Konstr.	LC	Ritad	LC	Godk.	MR	Smst nr.	Ers.		
Dat.	2021-08-17	Skala	1:5			Intra Nivis 82DF Art.no: XNIV82DF		Ritn.nr	15815
intra SCANDINAVIAN DESIGN									Ändr. F

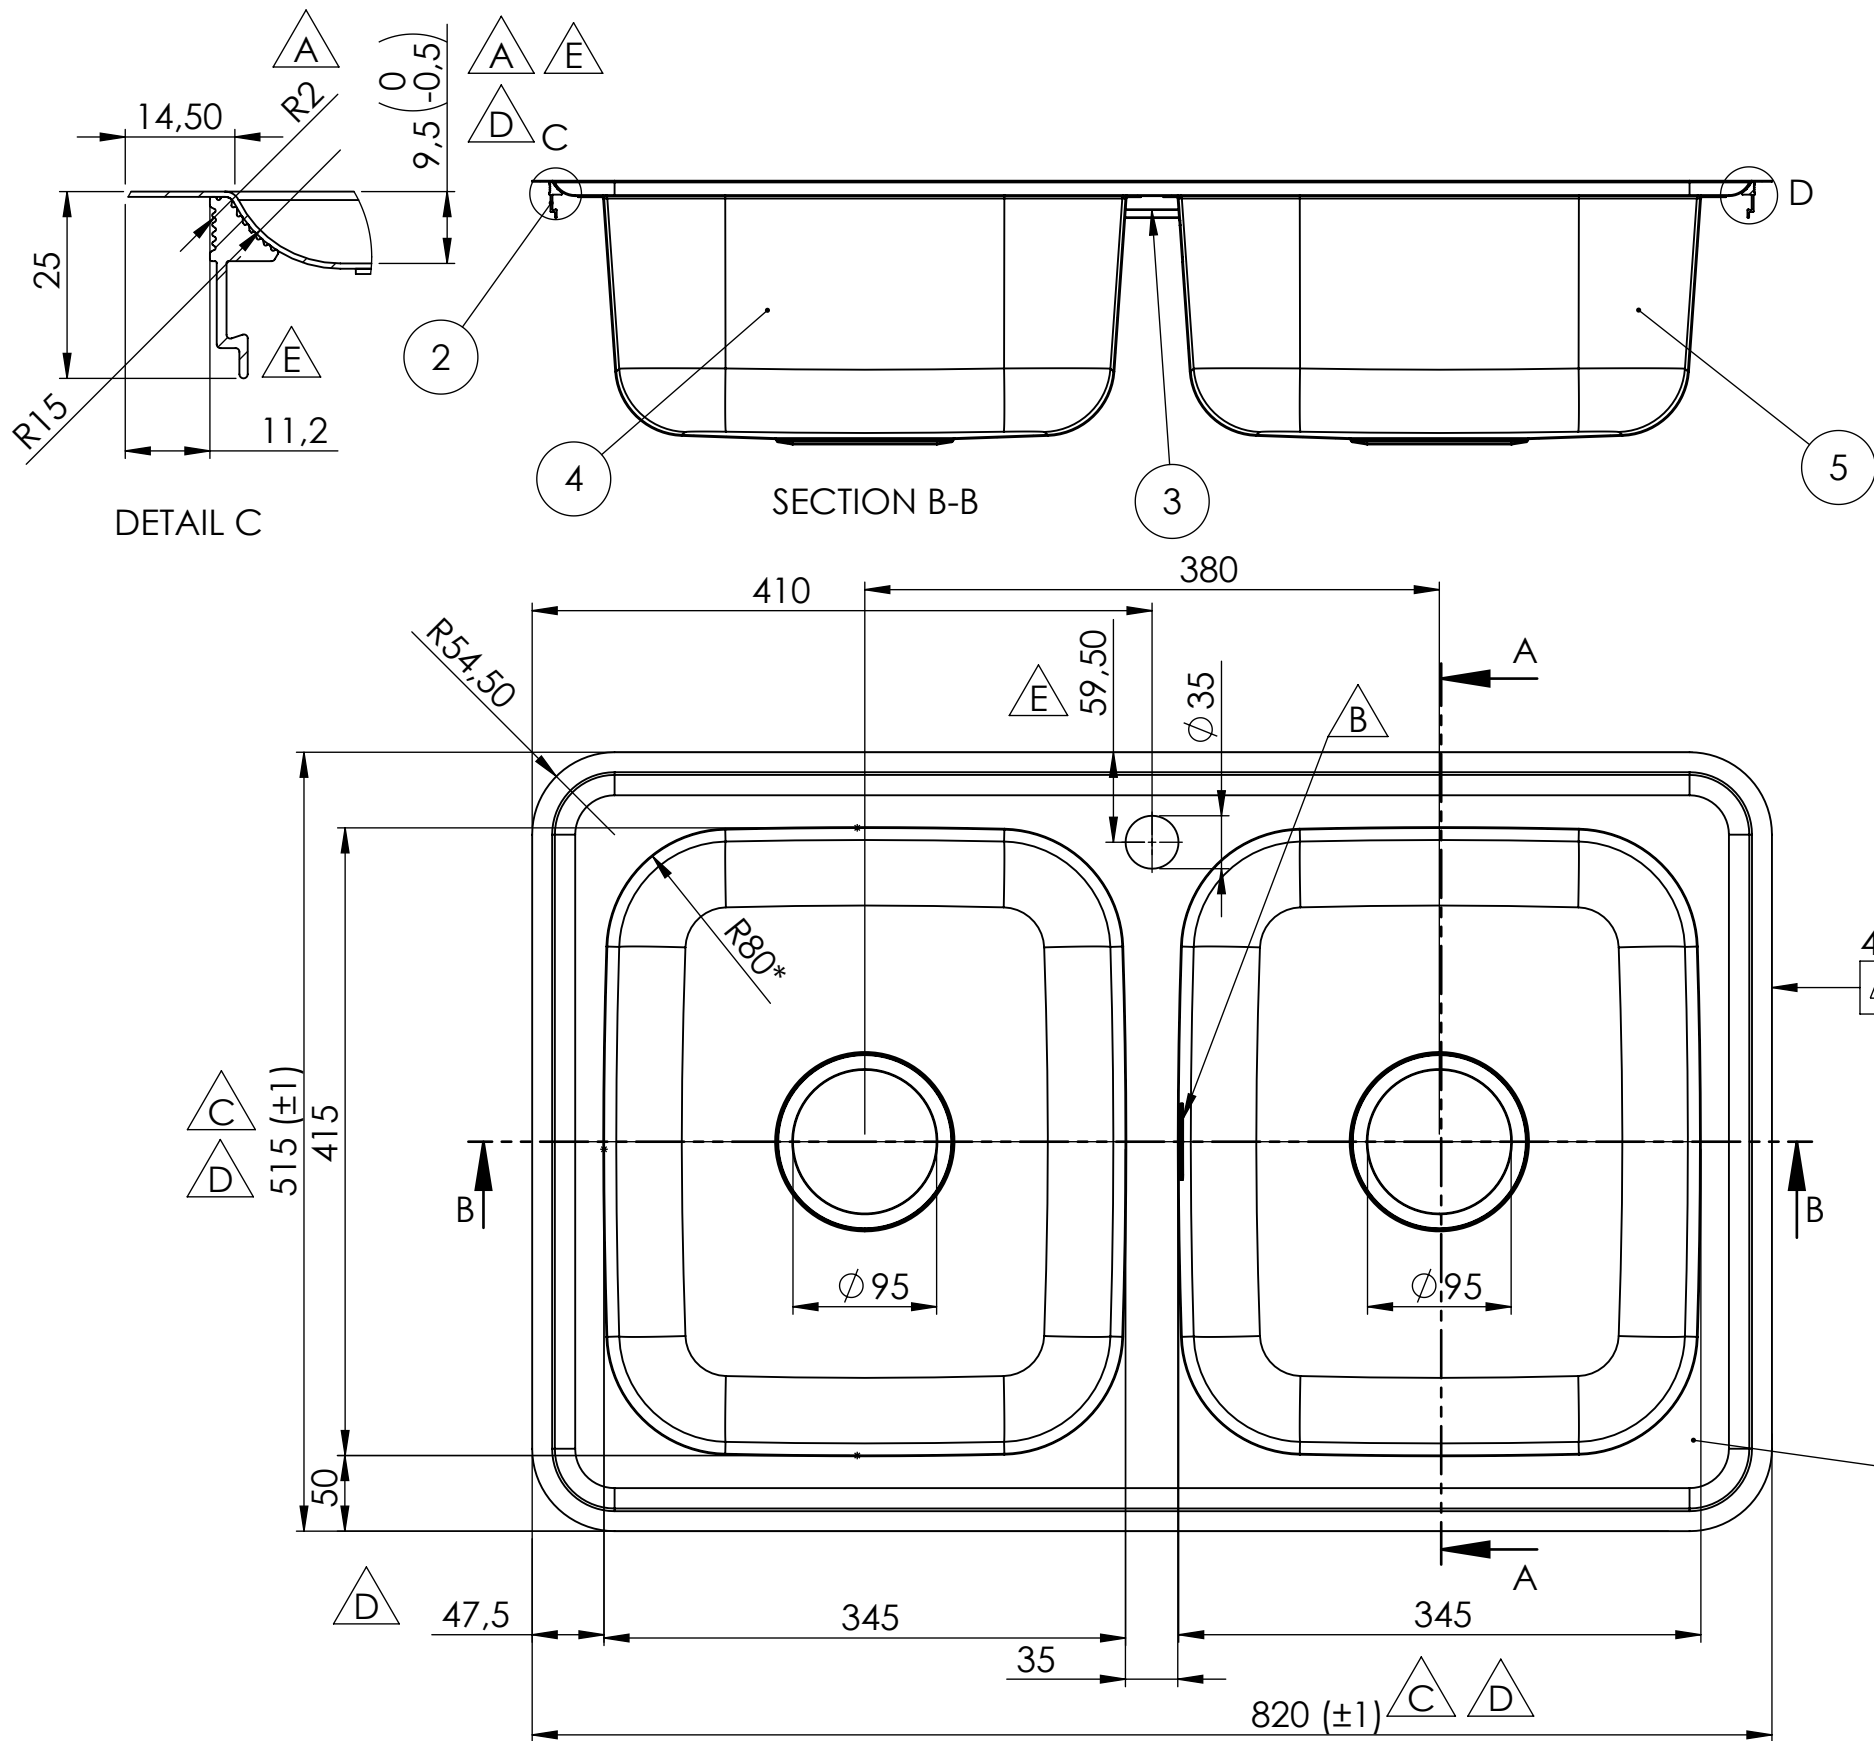
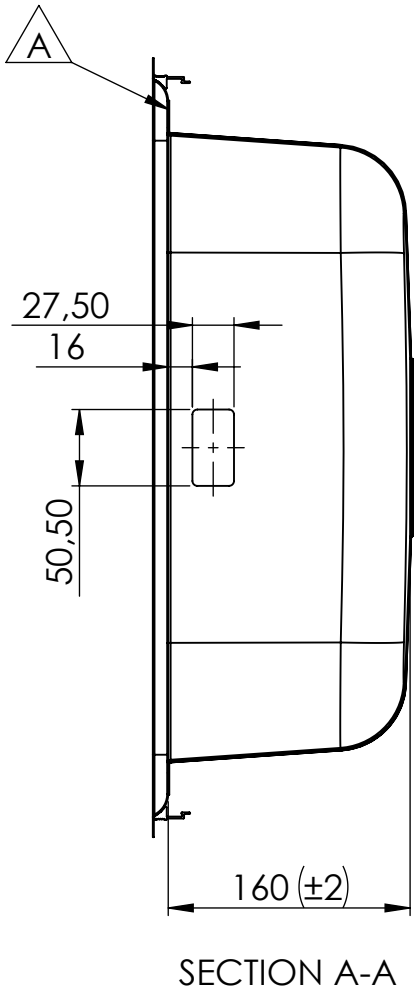
Rev.	Qty.	Change	Date	Sign.
A	3	R1 ->R2. R30 ->R15. A wider flange on the bowls that counteracts shrinkage stress during welding. Adaptation in the bowls flange for the tap hole to make the tap sit more firmly.	2022-01-21	MR
B	1	Overflow changed from left to right bowl to harmonize with Horizon.	2022-10-17	LC
C	3	Flatness tolerance 1,5 added. Tolerance (±1) added.	2022-11-23	LC
D	4	Dimensions changed from 815 -> 820, 510 -> 515, 8 -> 9, 47.5 -> 50, 45 -> 47.5. New tolerance.	2023-01-10	LC
E	4	Dimensions changed from 9 -> 9.5, 57 -> 59,50. New design of rails.	2023-01-31	LC
F	1	New name from Nivis 815DF -> Nivis 82DF because of dimension change.	2023-02-27	LC
